**UNITED STATES DEPARTMENT OF COMMERCE
Patent and Trademark Office**

APPLICATION NO.	FILING DATE	FIRST NAMED INVENTOR	ATTORNEY DOCKET NO.
09/135,926	08/18/98	BUSBOOM	G

Office Action Summary

DETAILED ACTION

Modified Figure

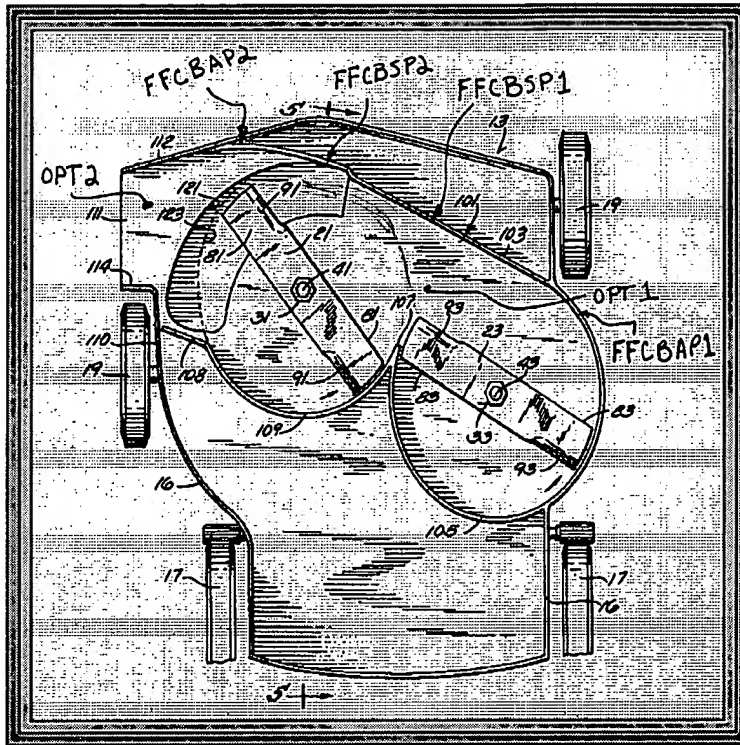
Kidd shows the first flow control baffle comprising a first arcuate baffle portion (FFCBAP1), a first elongated and substantially straight baffle portion (considered the combination of FFCBSP1 & FFCBSP2) and a second arcuate baffle portion (FFCBAP2) as shown in the enclosed modified figure. Kidd further shows the first elongated and substantially straight baffle portion being angularly disposed with respect to the blade tip path of the second cutting blade.

Concerning claim 12, Kidd shows the first and second flow control baffles having spaced-apart arcuate portions (FFCBAP1 & FFCBAP2, 105 & 109) which cooperate to define a semi-enclosed cutting chamber extending partially around the blade tip path of each of said cutting blades as shown in figure 4 and better identified in the inserted figure below.
